**CITY OF KELOWNA  
MEMORANDUM**

**DATE:** August 13, 2007  
**TO:** City Manager  
**FROM:** Planning & Development Services Department  
**APPLICATION NO.** Z07-0014      **APPLICANTS:** Tessco Inc.  
**AT:** 1923 Ambrosi Road      **OWNER:** 1314696 Alberta Ltd.  
1937 Ambrosi Road  
1979 Ambrosi Road  
1926 Barlee Road

**PURPOSE:** TO REZONE THE SUBJECT PROPERTIES FROM THE RU1 – LARGE LOT HOUSING ZONE TO THE RM5 - MEDIUM DENSITY MULTIPLE HOUSING ZONE IN ORDER TO ALLOW FOR THE CONSTRUCTION OF A 4 ½ - STOREY, 72-UNIT APARTMENT BUILDING..

**Date:** August 2, 2007  
**File No.:** Z07-0014 DP07-0039 DVP07-0040 OCP07-0006  
**To:** Planning & Development Services Department (NW)  
**From:** Development Engineering Manager Revised Comments  
**Subject:** Proposed 72 Unit Residential Condominium Tessco Inc.  
1937 - 1979 Ambrosi Road Lots 6, 7, 8 Plan 14187 Lot A Plan 34047

PREPARED BY  
PARKADE

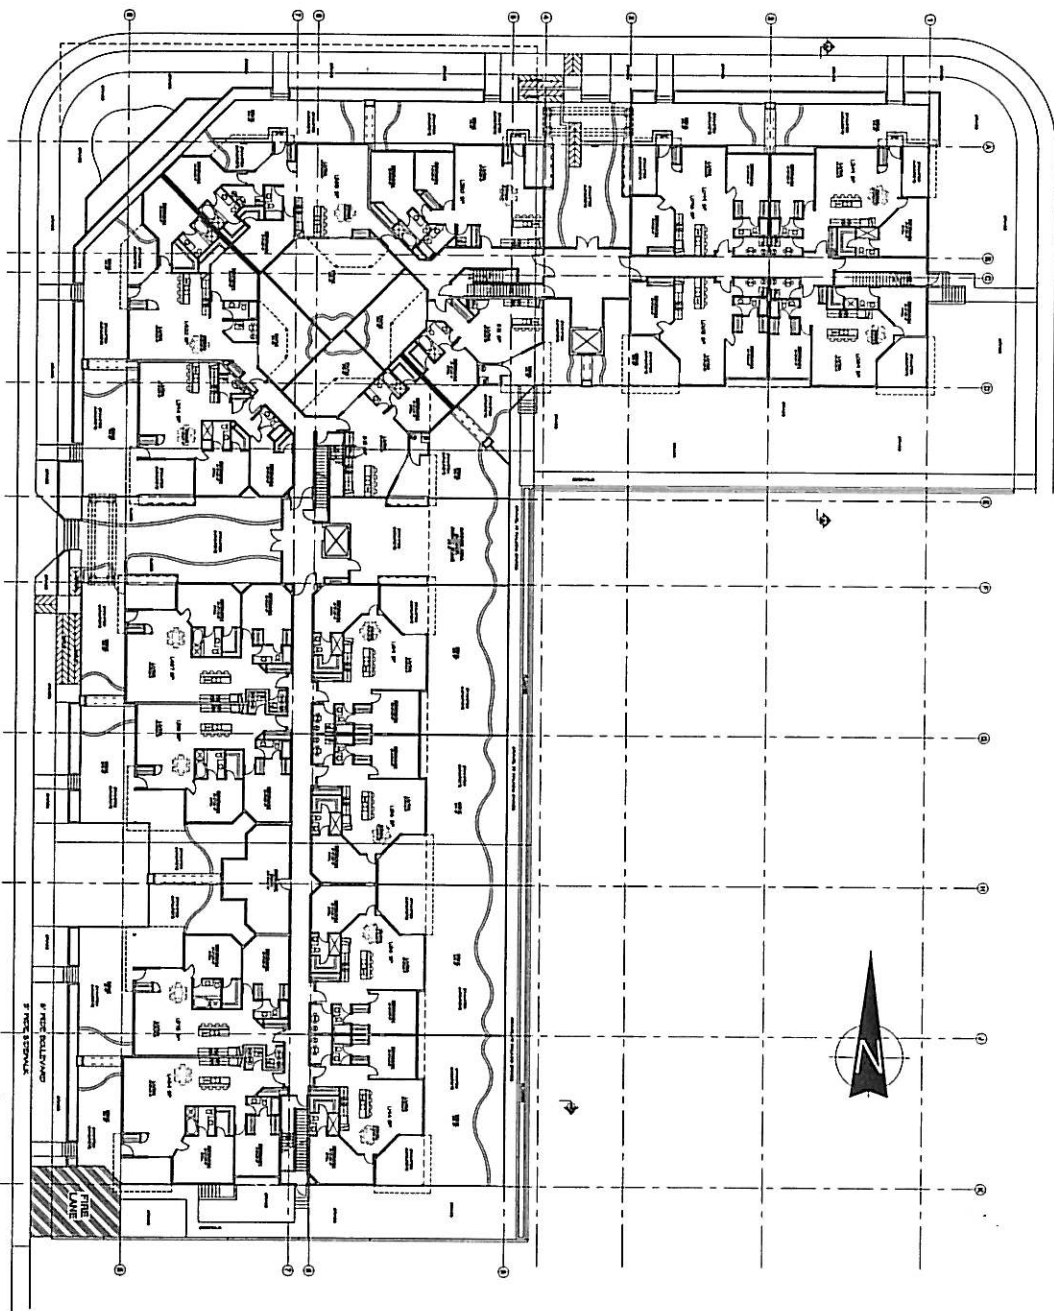
<sup>D</sup> The applicant will be required to annotate the drawings to show which stalls are designated for visitors.
